**APPLICATION FOR
URBAN DESIGN COMMISSION
REVIEW AND APPROVAL**

PROJECT ADDRESS: 2 S. Bedford Street

Re: Letter of Intent
Minor Alteration to an Approved and Recorded SIP
2 South Bedford Street
Madison, Wisconsin

SITE PLAN
1/16" = 1'-0"

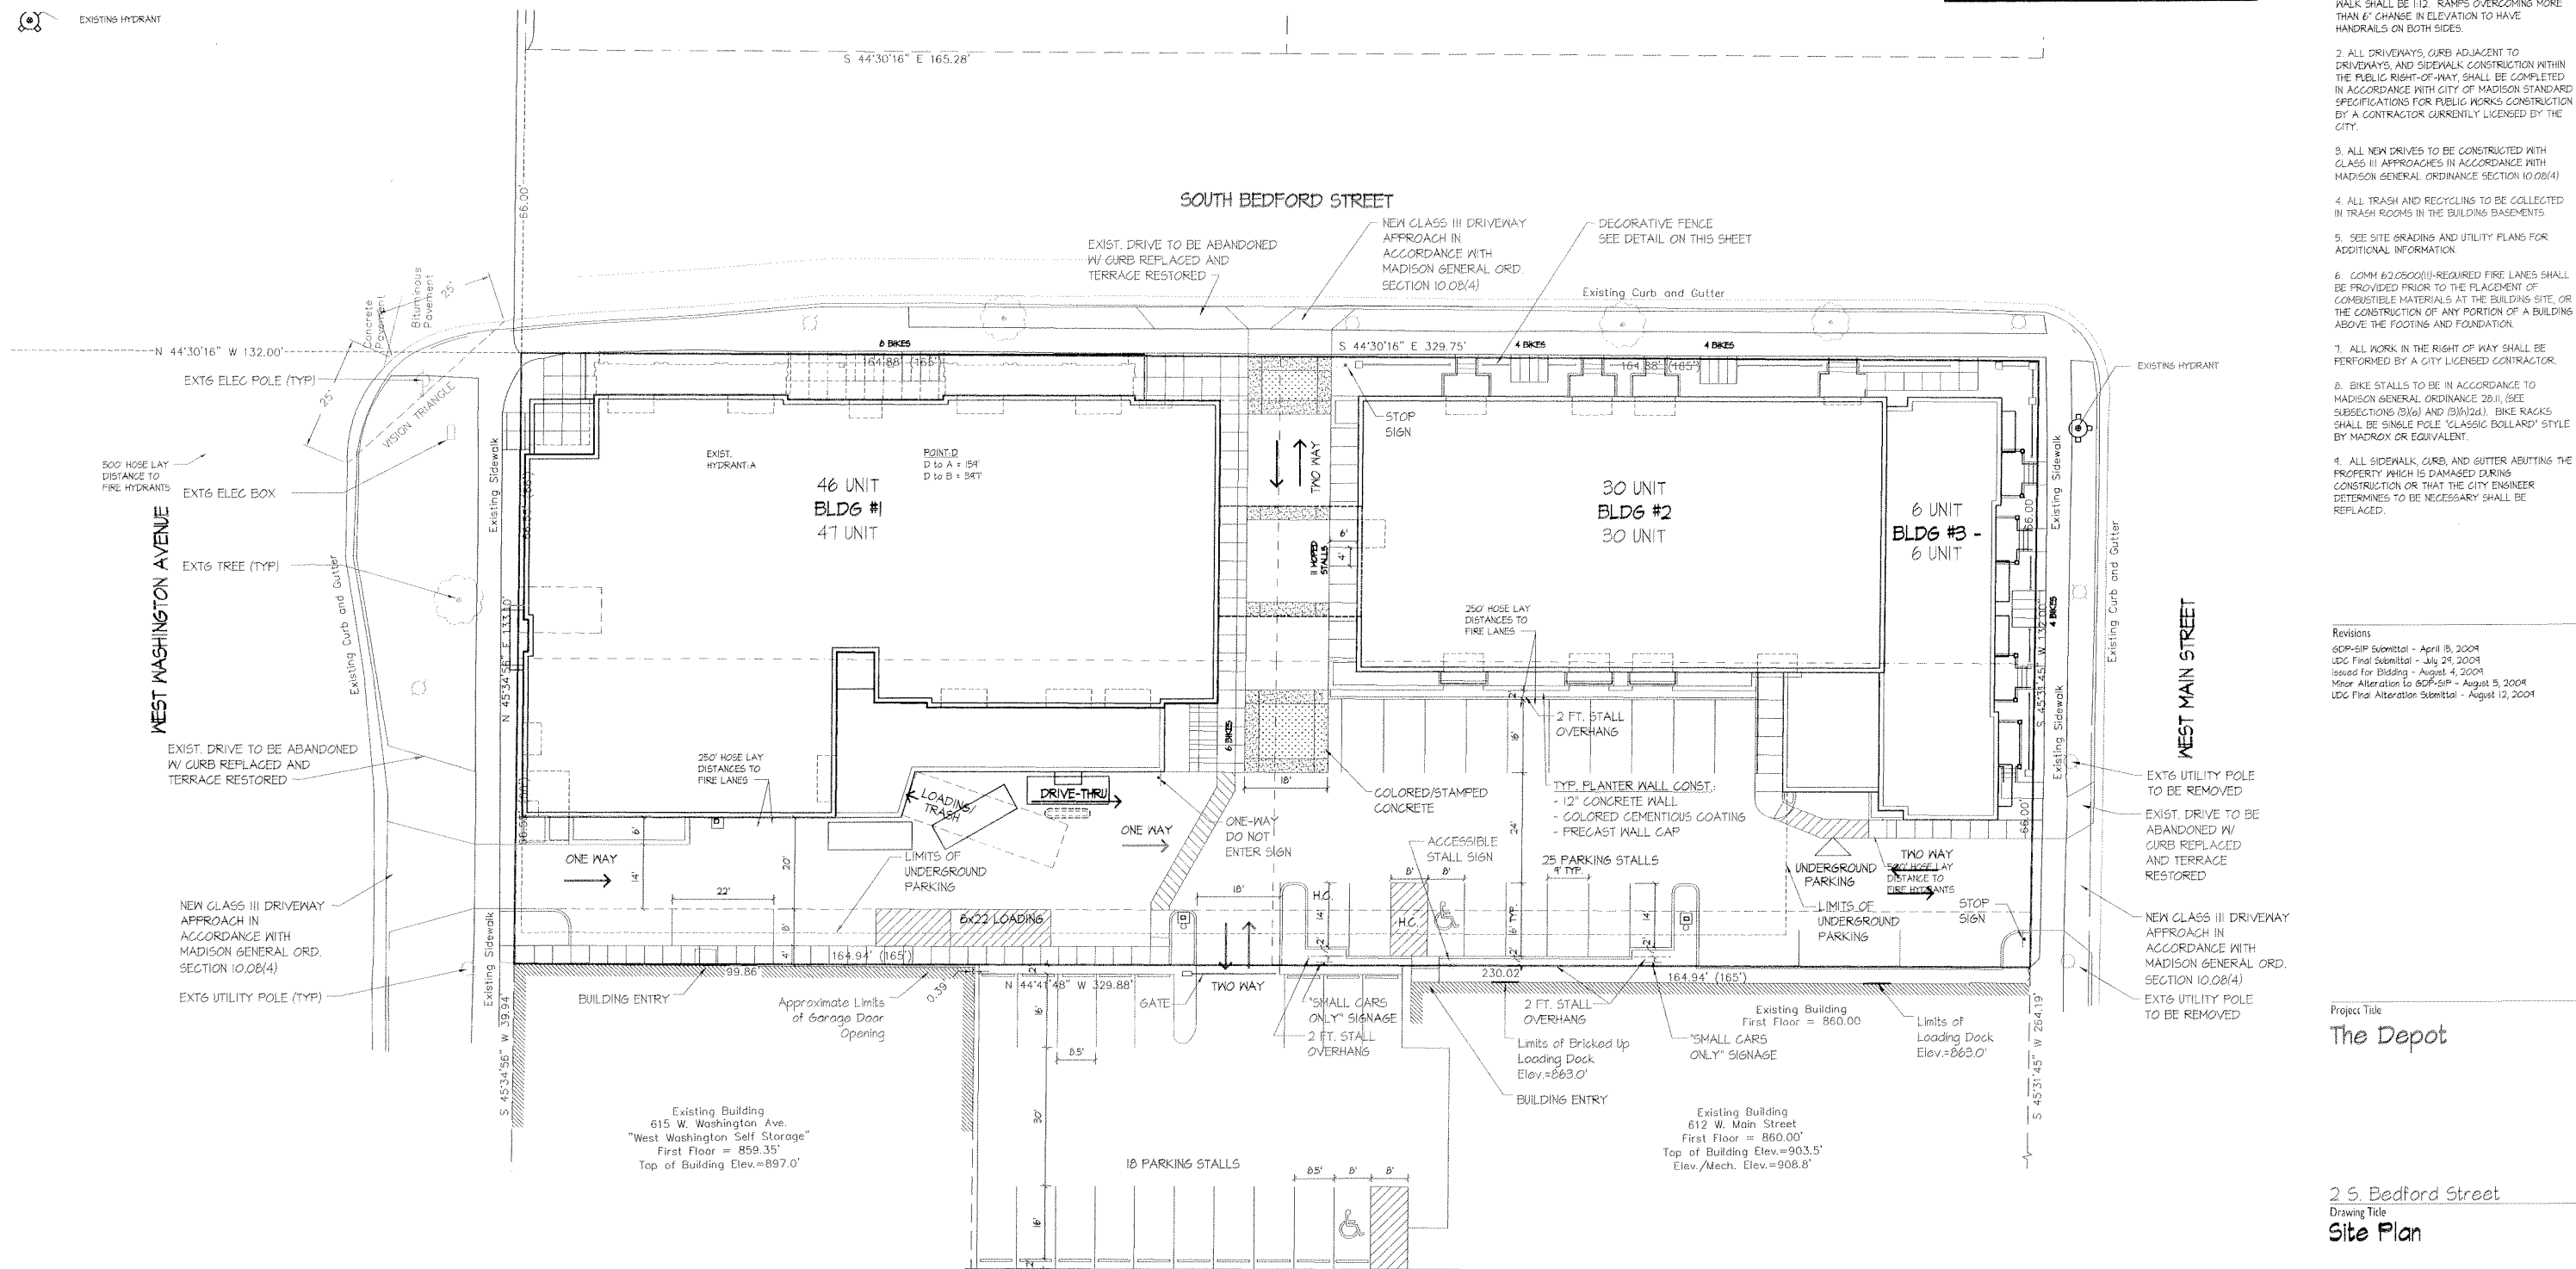
The following is submitted together with the plans, application and zoning text for staff and Plan Commission consideration of approval. We are proposing a drive-thru area on the back side of Building #1.
